WT Young Library Renovation

PROJECT 3050.1

ADDENDUM #6

**WT YOUNG LIBRARY
LOWER LEVEL RENOVATION**

MECHANICAL - CONTROLS SHEET

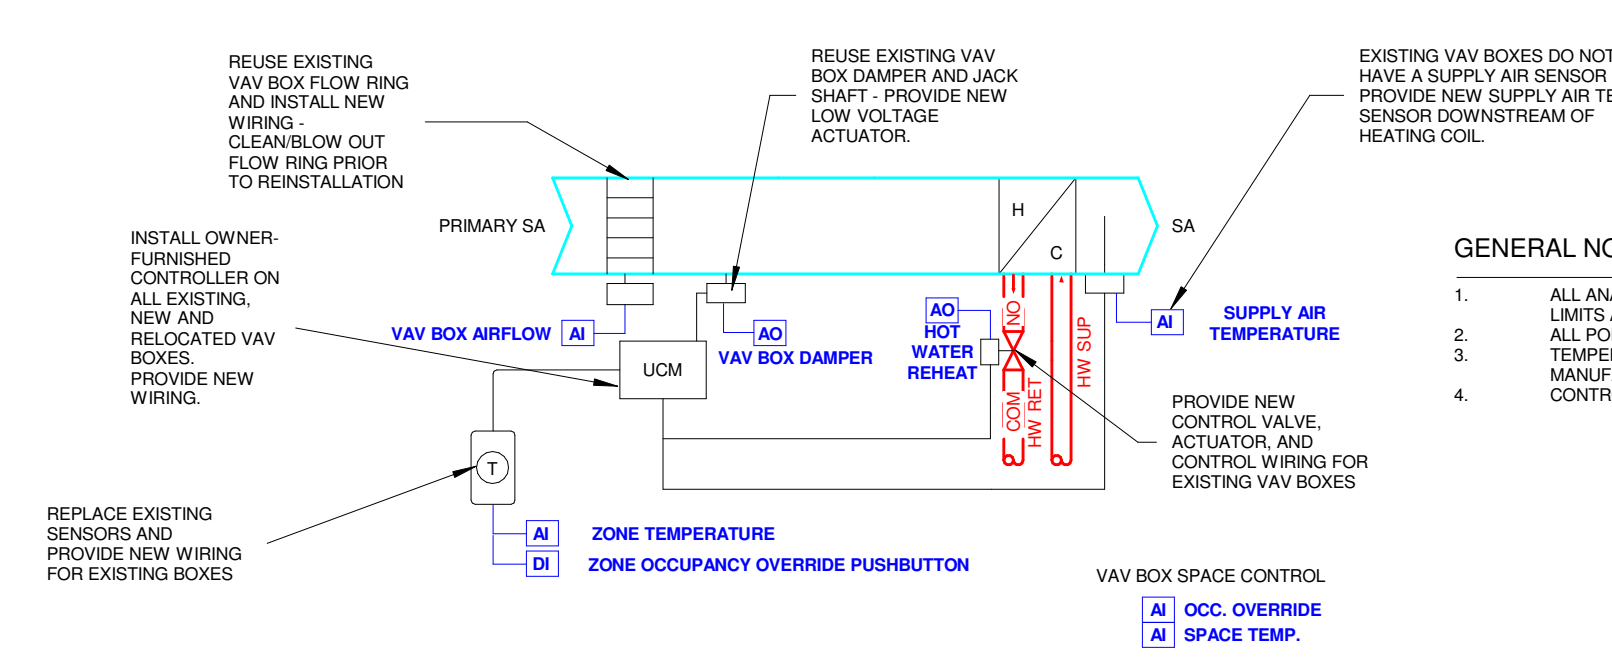
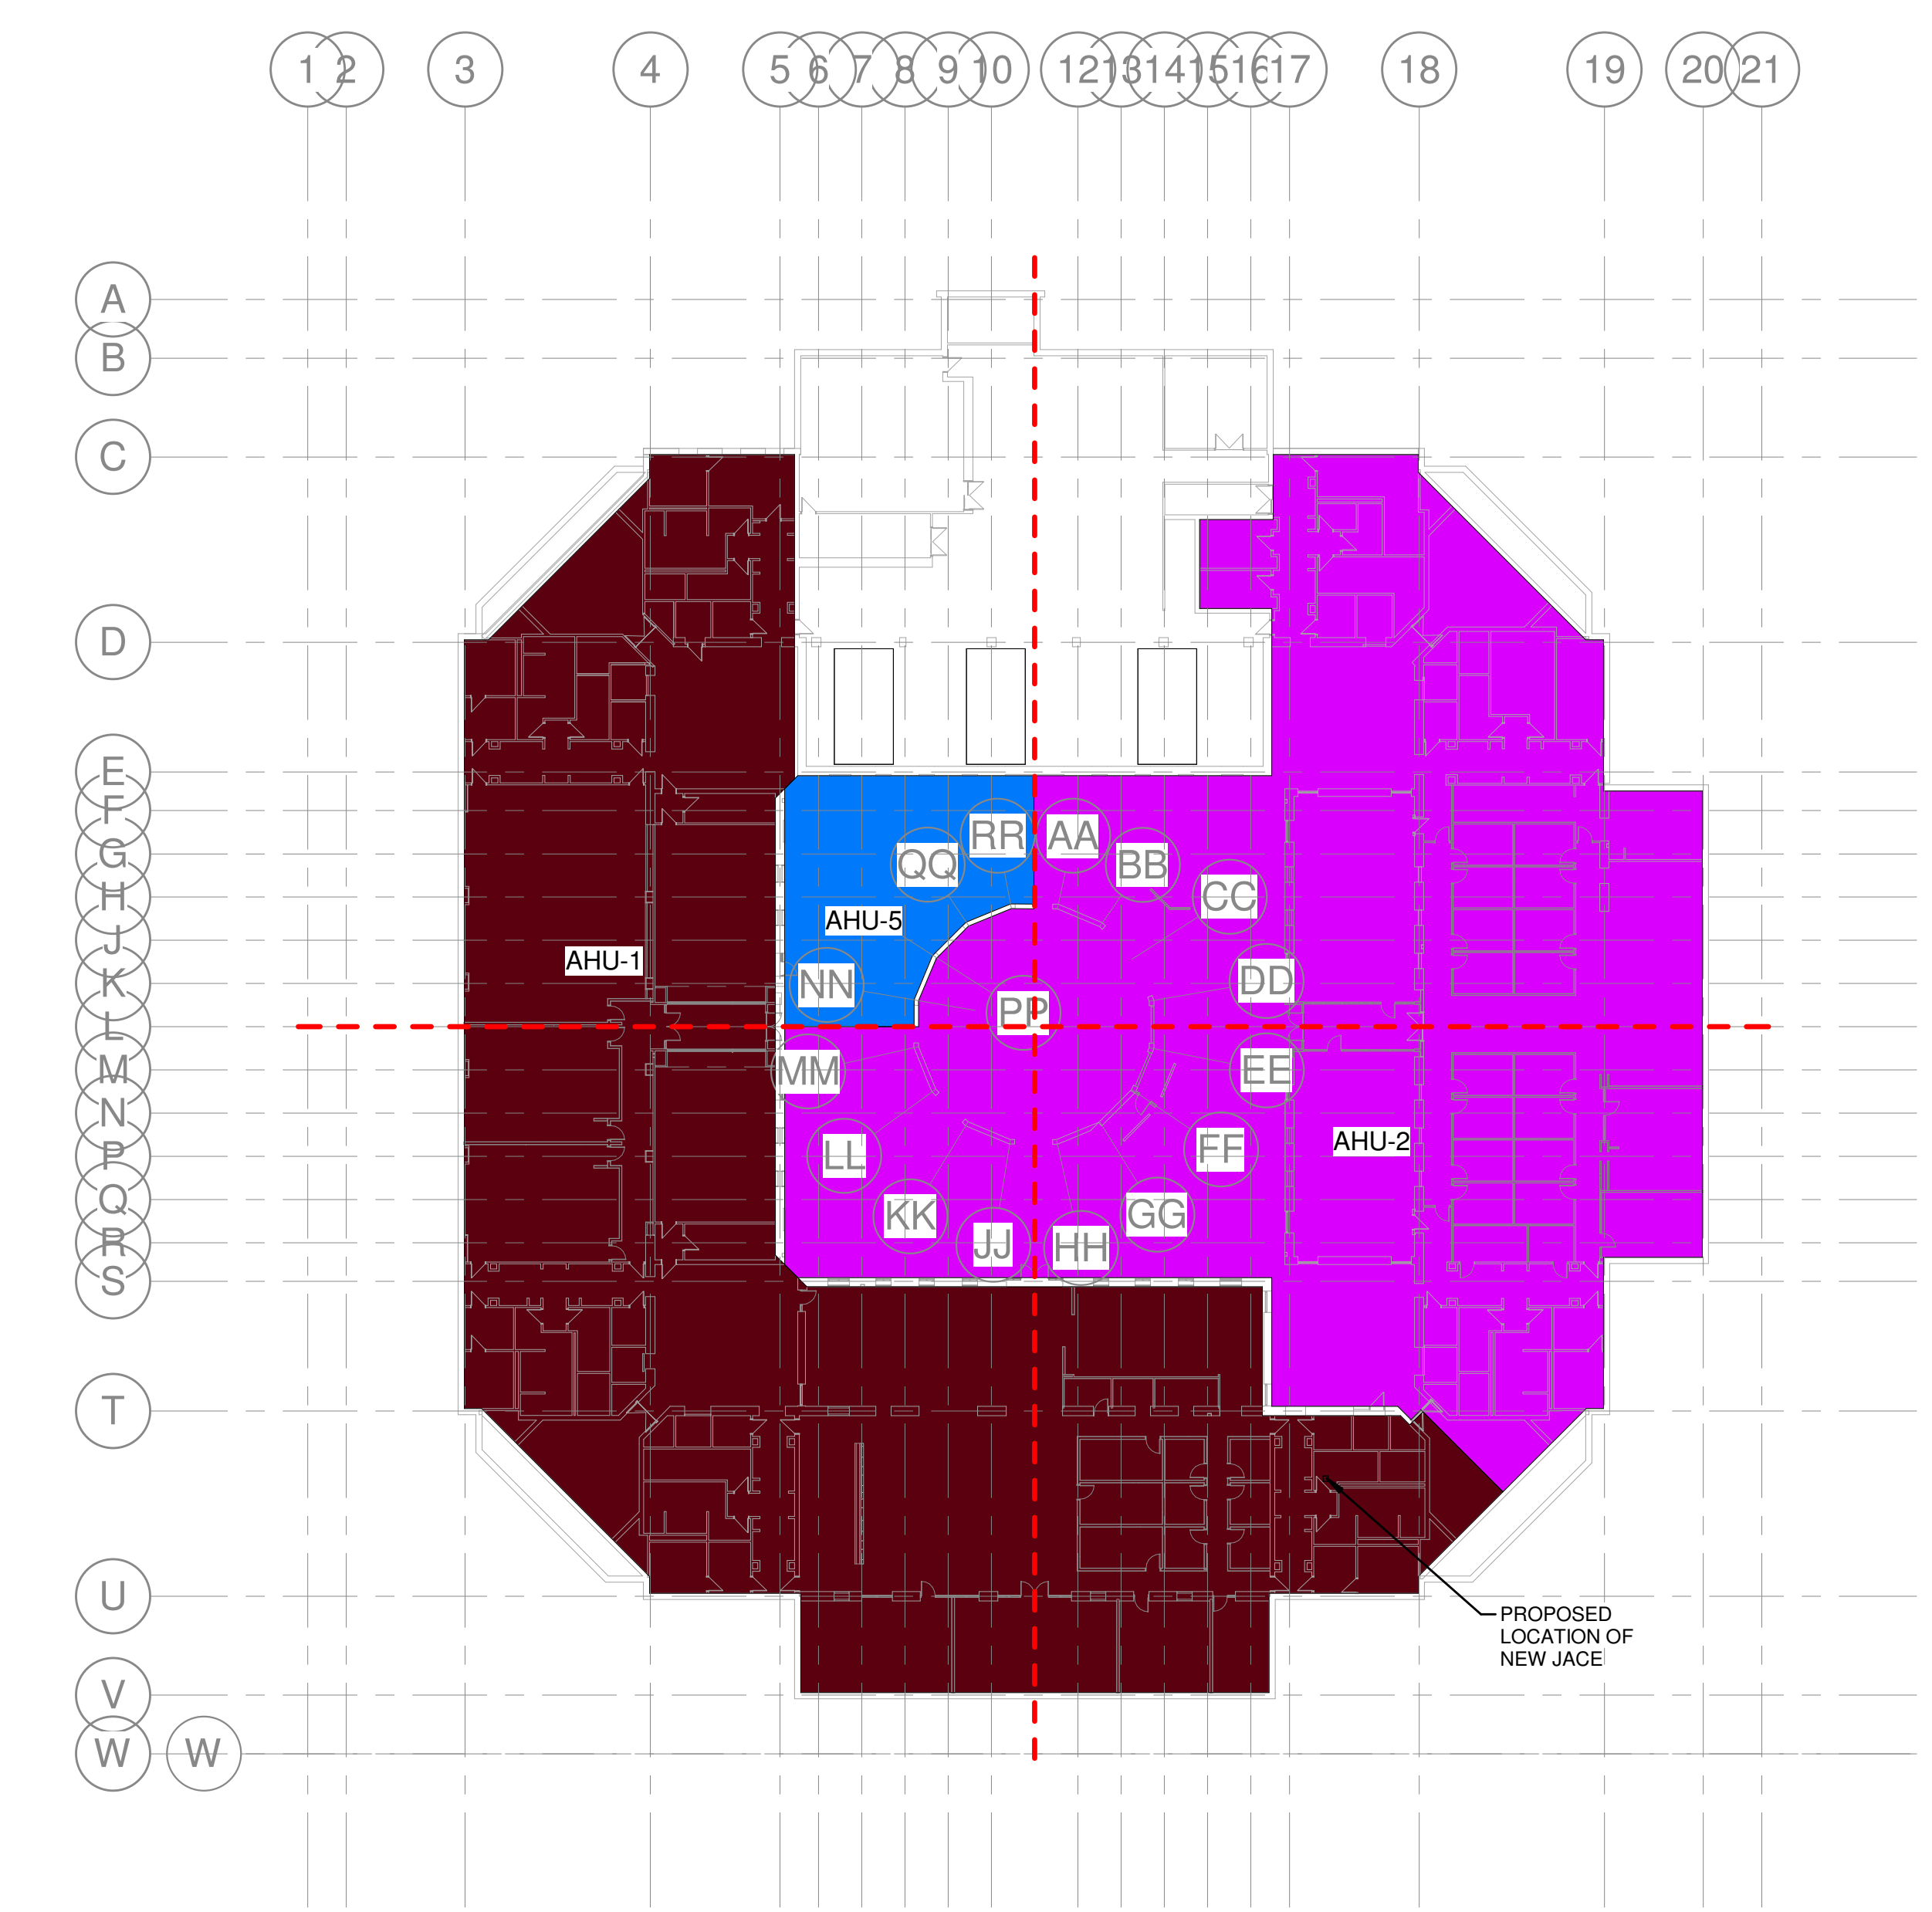
<p>It appears UK will be providing the DDC controllers.</p> <p>Can you please confirm what Manufacture and controller model UK will be using?</p> <p>We will need this to quote the thermostat / sensors.</p>	<p>UK is furnishing Distech ECB-VAV controllers for the project.</p>

- Sheet IC-001 - Mechanical - Controls Sheet
 - a) Added Make/Model of UK-furnished VAV controller.

UK FURNISHED VAV CONTROLLER, DISTECH ECB-VAV CONTROLLER.

M-001

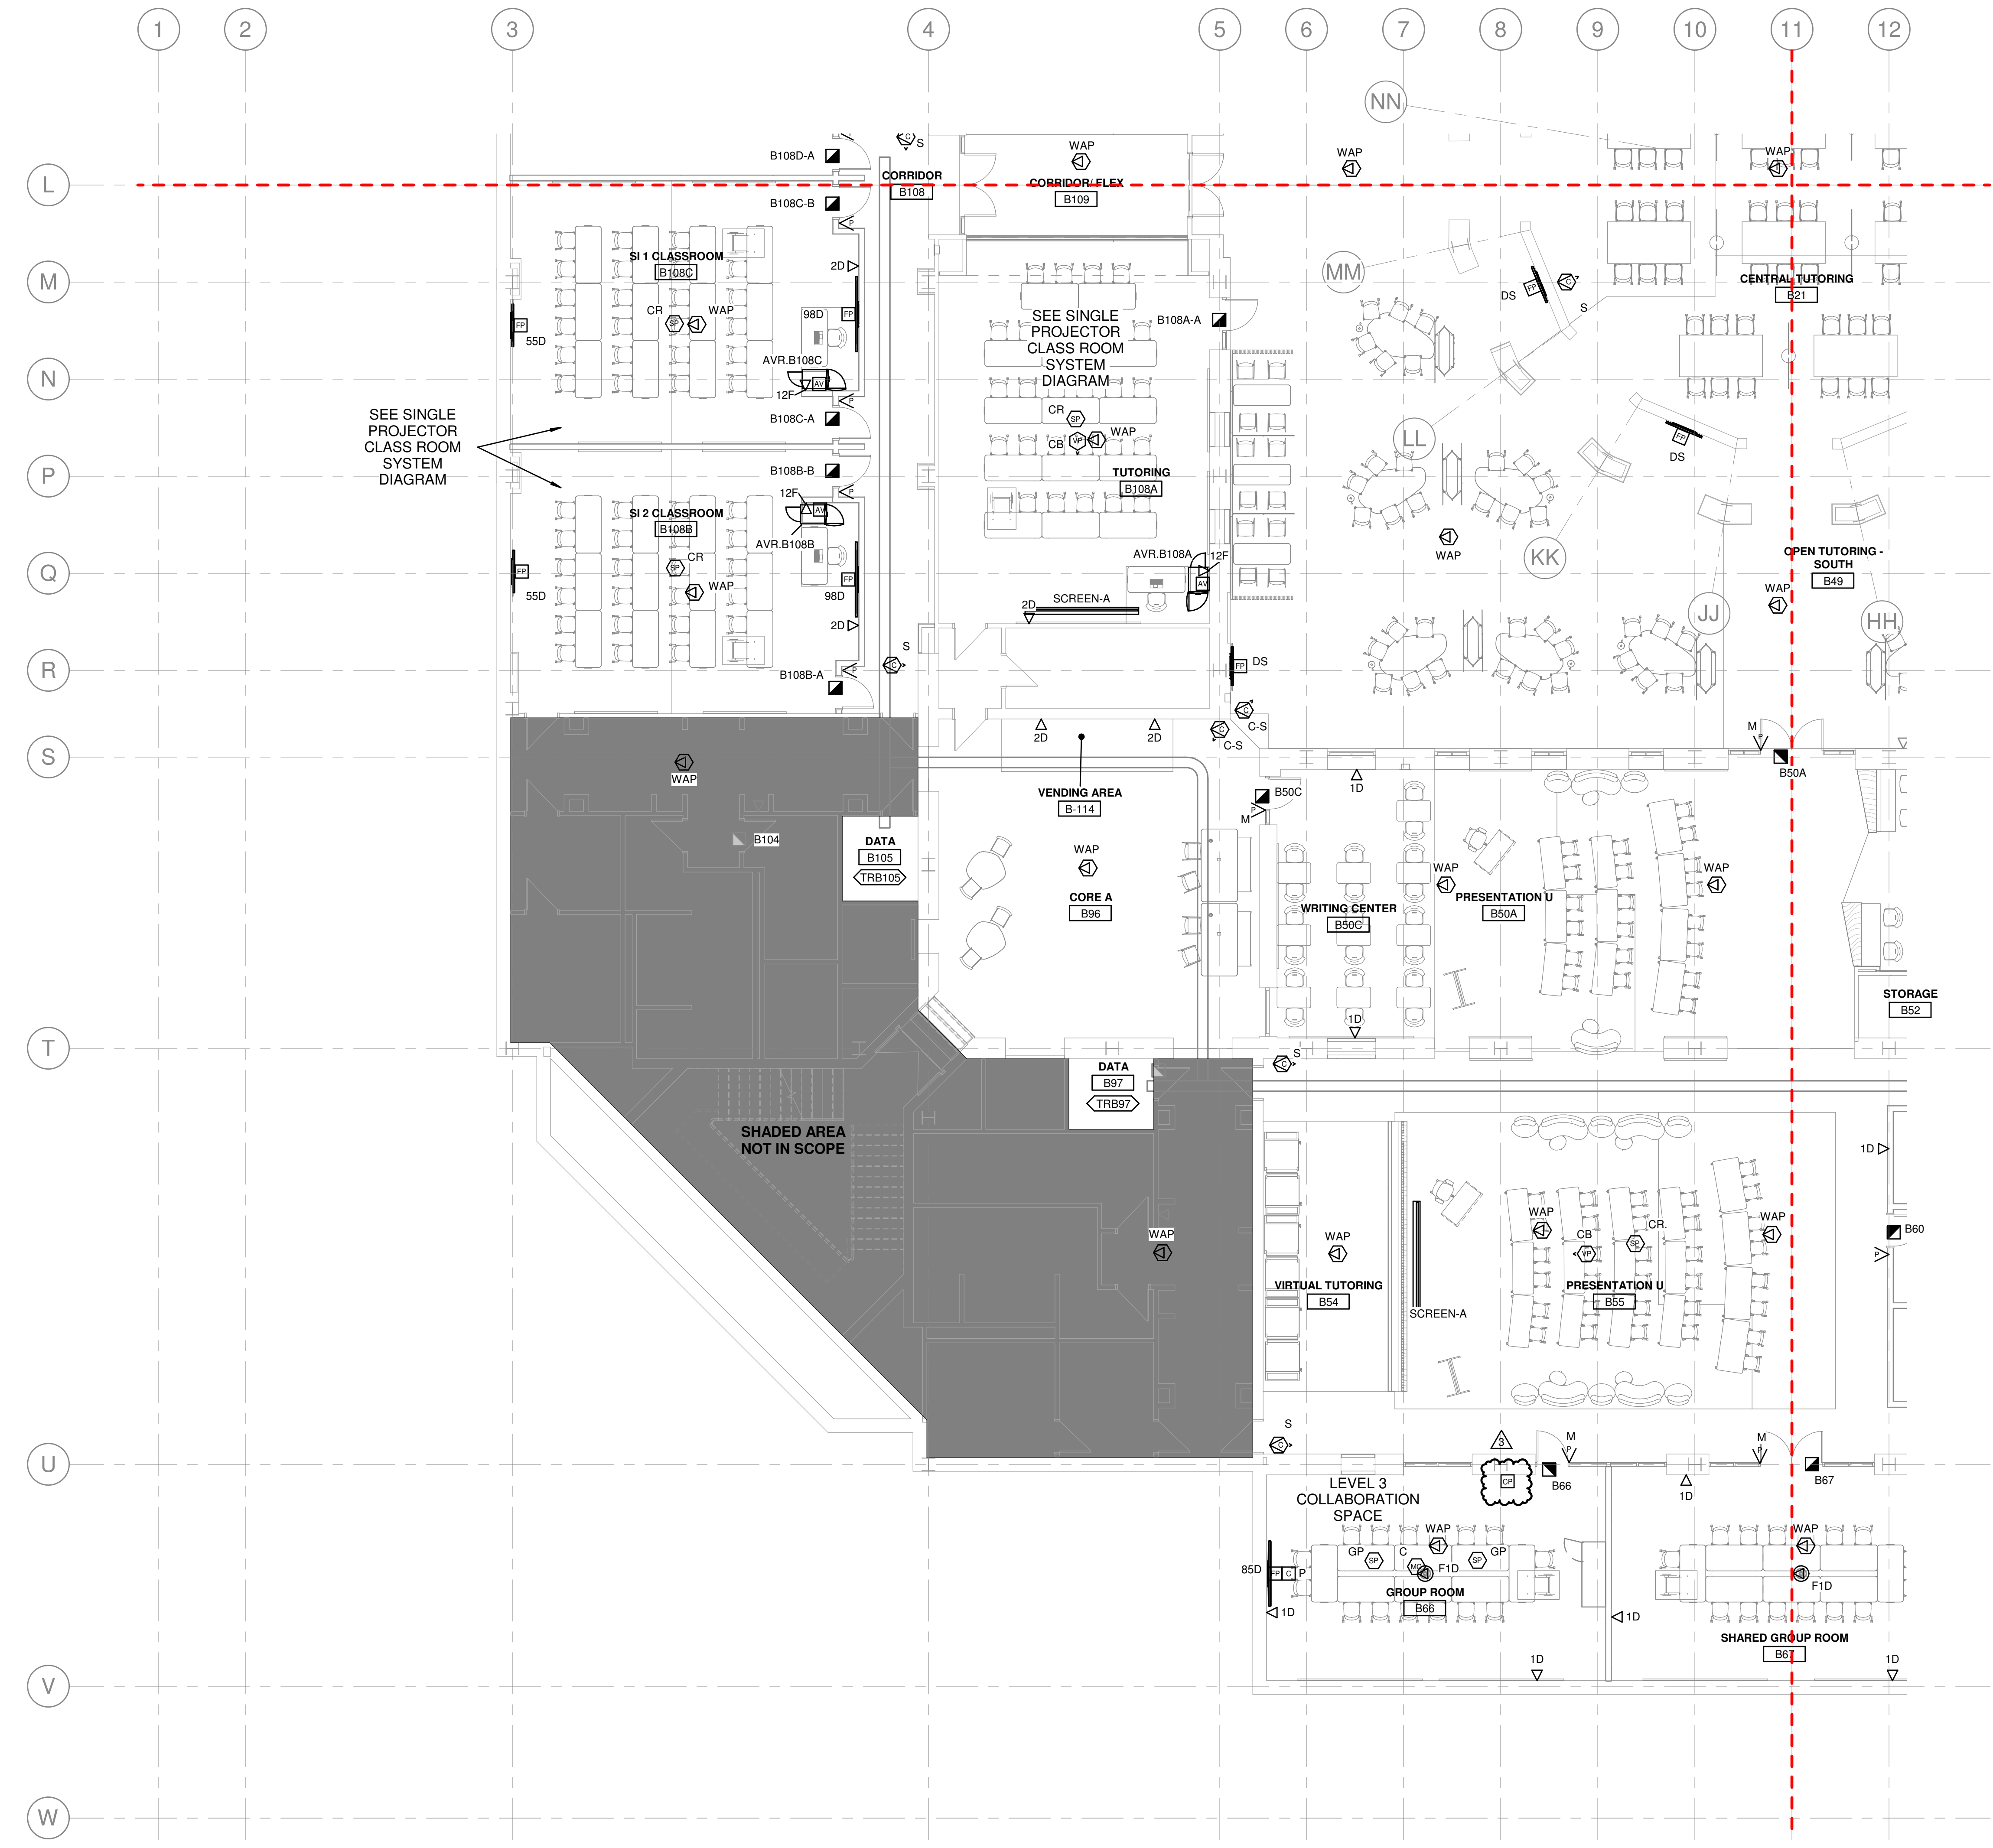
<p>This wording is confusing and concerning for multiple reasons, and is the first mention of fully replacing the old units. Concerns include but are not limited to:</p> <ul style="list-style-type: none"> - If Base Bid only is accepted (in reference of Alt 5), of the 44 “to remain” VAVs/Reheats, would we actually need to include new control wiring and device mounting for all of these? Does that include a new control valve too? Some of these 44 “remaining” devices are in locations of the ground floor that aren’t even in the footprint of the renovated space and we would need access above ceiling/protection of finished surfaces in all surrounding areas... - Is Alternate #5 requesting the bidder to provide and install 44 additional new VAVs/reheat coils and install them in place of the existing 44 set to remain? As stated above, some of these are outside of the footprint of renovated area, and accessing them for new unit installation, hot water connections, and duct transitions is a significant undertaking, esp. in areas not covered with ceiling removal or surface protection in the main bid. The alternates have been confusing but this version is the first I am seeing that suggests we’re actively meant to replace existing units in areas of the building we aren’t even working in. - The actual HVAC Equipment Schedule sheet doesn’t provide new equipment selections for any of the existing “remaining” or “relocated” VAVs/Reheat coils. We MUST be given further information and models/selections if we are actually meant to price replacing those VAVs/reheats in any capacity. 	<p>Language has been clarified in Addendum 6 to list which VAV boxes are out of scope/the area of renovation - these out-of-scope VAV boxes will only need to be rebalanced at the end of the project.</p> <p>Information for selecting new VAV boxes to replace the old ones (max/minimum CFM and heating MBH) can be found in the VAV schedule on M-601 (sheet will not be reissued in Addendum 6 due to that information already being contained within the drawings and the new boxes having the same performance criteria as the boxes they're replacing).</p>

- Sheet M-001 - Mechanical Cover Sheet
 - a) Updated "HVAC Alternates" block to address some field questions regarding out-of-scope boxes and questions on selecting new equipment to replace existing.

HVAC ALTERNATES

ALTERNATE NO. 4: RELOCATED VAV BOXES

BASE BID: REFER TO THE MECHANICAL DRAWINGS. THE 23 EXISTING HOT WATER VAV BOXES TO BE RELOCATED TO RECEIVE CONTROLS UPGRADES (OLD DDC STANDARD TO NEW DDC STANDARD) IN THE BASE BID. CONTROLLERS ARE OWNER-FURNISHED, CONTRACTOR-INSTALLED.

ALTERNATE BID: THE 23 EXISTING VAV BOXES TO BE RELOCATED WILL BE REPLACED WITH NEW CONTROLLERS ARE OWNER-FURNISHED, CONTRACTOR-INSTALLED.

REFER TO M601 FOR MAXIMUM AND MINIMUM AIRFLOWS ALONG WITH HEATING MBH TO ALLOW FOR SELECTION OF NEW EQUIPMENT TO MATCH THE PERFORMANCE OF EXISTING. REFER TO NEW VAVS WITHIN THAT SAME SCHEDULE FOR VAV BASIS OF DESIGN.

ALTERNATE NO. 5: VAV BOXES TO REMAIN

BASE BID: REFER TO THE MECHANICAL DRAWINGS. EXISTING HOT WATER VAV BOXES TO REMAIN IN PLACE TO RECEIVE CONTROLS UPGRADES (OLD DDC STANDARD TO NEW DDC STANDARD) IN THE BASE BID. CONTROLLERS ARE OWNER-FURNISHED, CONTRACTOR-INSTALLED.

ALTERNATE BID: THE 44 EXISTING VAV BOXES TO REMAIN IN PLACE WILL BE REPLACED WITH NEW CONTROLLERS ARE OWNER-FURNISHED, CONTRACTOR-INSTALLED.

REFER TO M601 FOR MAXIMUM AND MINIMUM AIRFLOWS ALONG WITH HEATING MBH TO ALLOW FOR SELECTION OF NEW EQUIPMENT TO MATCH THE PERFORMANCE OF EXISTING. REFER TO NEW VAVS WITHIN THAT SAME SCHEDULE FOR VAV BASIS OF DESIGN.

COMMON TO THESE ALTERNATES:

NEW CONTROL VALVES, NEW ACTUATORS, AND NEW CONTROL WIRING TO BE PROVIDED FOR ALL EXISTING TO-REMAIN AND RELOCATED VAVS.

THERE ARE (9) VAV BOXES (V1-B97, V1-B-E92, V1-B-117, V1-B-E11, V2-B-E11, V2-B-E12, V2-B-114, V2-E99, AND V1-B444) THAT ARE EXISTING TO-REMAIN AND SERVE OUT-OF-SCOPE AREAS. THESE BOXES WILL NOT RECEIVE CONTROLS VALVES/ACTUATORS - ONLY SCOPE FOR THESE BOXES IS PRE-CONSTRUCTION BALANCING AND THEN RE-BALANCING TO PRE-CONSTRUCTION AIR/WATER FLOWS AT THE PROJECT CLOSEOUT.
